COUNCIL ASSESSMENT SUPPLEMENTARY REPORT - FEMP

Panel Reference	PPSNTH-129
DA Number	DA2021/0558
LGA	Clarence Valley Council
Proposed Development	Multi Dwelling Housing (136 Dwellings, one exhibition home, community facilities including clubhouse, swimming pool, gym and cinema, associated infrastructure and landscaping)
Street Address	Park Avenue, Yamba NSW 2464
Applicant/Owner	Applicant: Hometown Australia Management Pty Ltd Owner: Parkes Menai P/L

This supplementary report is provided in response to the Independent Peer Review of the Flood Emergency Management Plan (FEMP) undertaken by Rhelm on behalf of the Department of Planning and Environment relating to the abovementioned development.

Figure 1: Draft climate change flood modelling scenarios for Yamba.

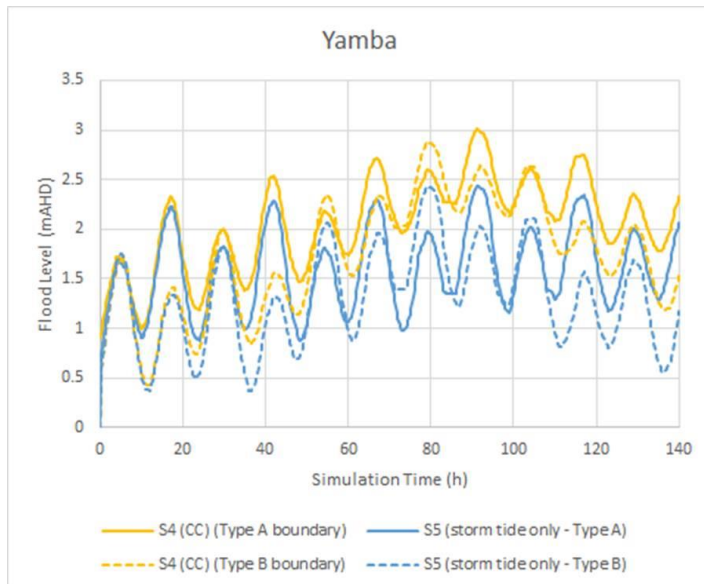
It is noted that Rhelm may not be aware that BMT has been engaged recently by Council to review the current Clarence Flood model. Draft climate change flood scenarios for Yamba, which are yet to be finalised or adopted by Council, were provided for discussion between Council and the Department of Planning & Environment (DPE) on 30/09/2022 and suggest that the 1% AEP flood level under a Climate Change scenario is either 2.85m AHD or 3.05m AHD depending on the ocean boundary adopted. What Council staff are currently discussing with DPE is whether the "Type B" boundary is overly conservative (see Figure 1 below).

The Peer Review has recommended an additional 0.9m for Climate Change on top of Council’s adopted levels from the 2013 Flood Model which, as noted above, used an ocean storm tide level of 2.6m AHD compared with a predicted 2023 RCP8.5 1% AEP storm tide height of 2.75m AHD. Council staff note that the peer review recommendation to add 0.9m onto a projected 1% AEP event, which already incorporates predicted sea level rise, could be considered to be overly conservative and not supported by an updated flood model.
